# YZ125D, IT175D GEAR SHIFTING ADJUSTMENT

A change lever modification is strongly recommended for added shifting reliability for early production YZ125D and IT175D machines. In addition, the index mark on the change lever must be carefully aligned with the mark on the shift drum. Perform these adjustments as described in this Bulletin.

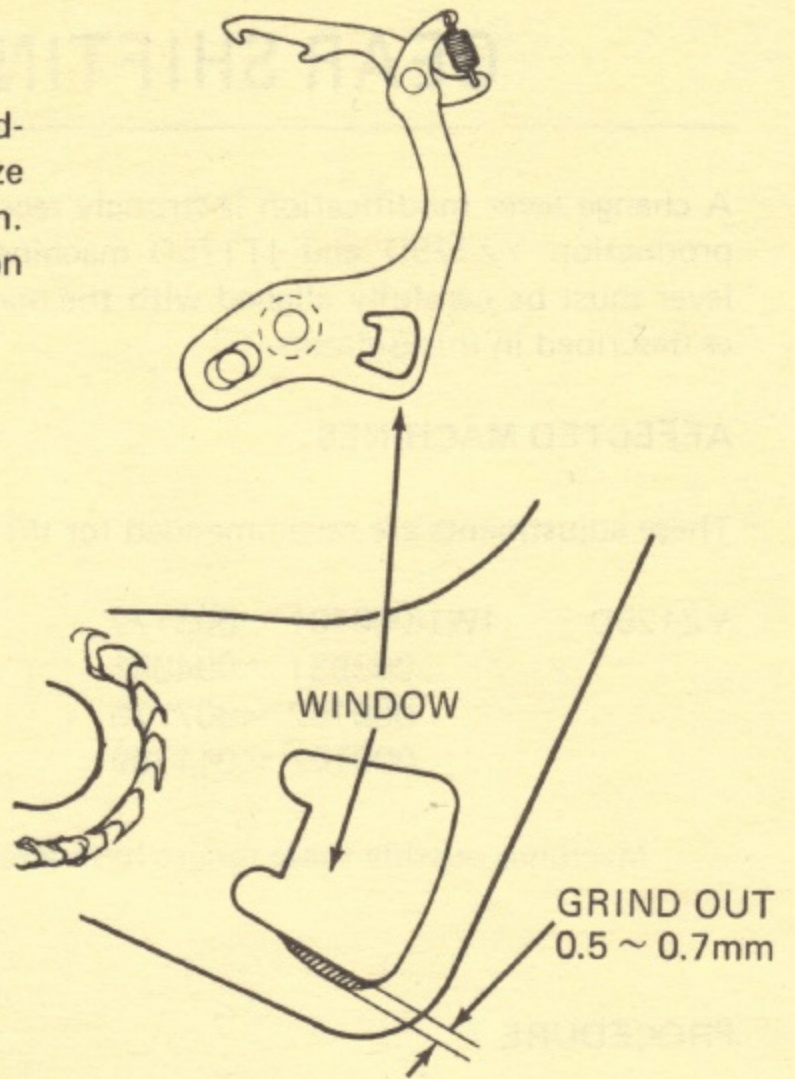
- Use a small-diameter stone in a hand-held grinding tool to increase the size of the change lever "window" as shown. **CAUTION:** observe eye protection precautions when grinding.

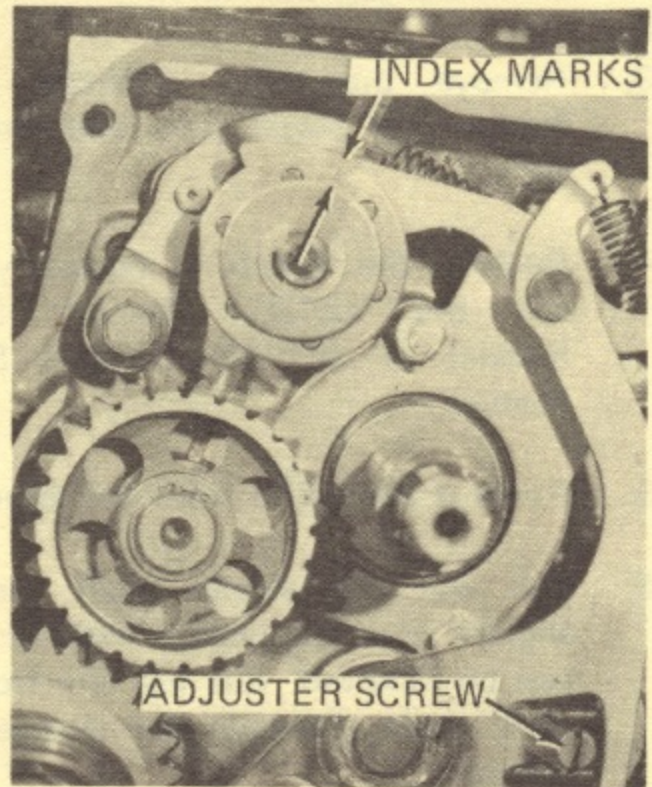
- Reassemble the change lever. Temporarily install the shift lever (left side of machine) and shift into first gear. With the shift mechanism completely assembled the index mark on the change lever should align perfectly with the index mark on the shift drum.

If the marks are not aligned, loosen the adjuster screw lock nut. Turn the adjuster screw lock nut. Turn the adjuster screw (an eccentric screw) until the marks are aligned. Tighten locknut.
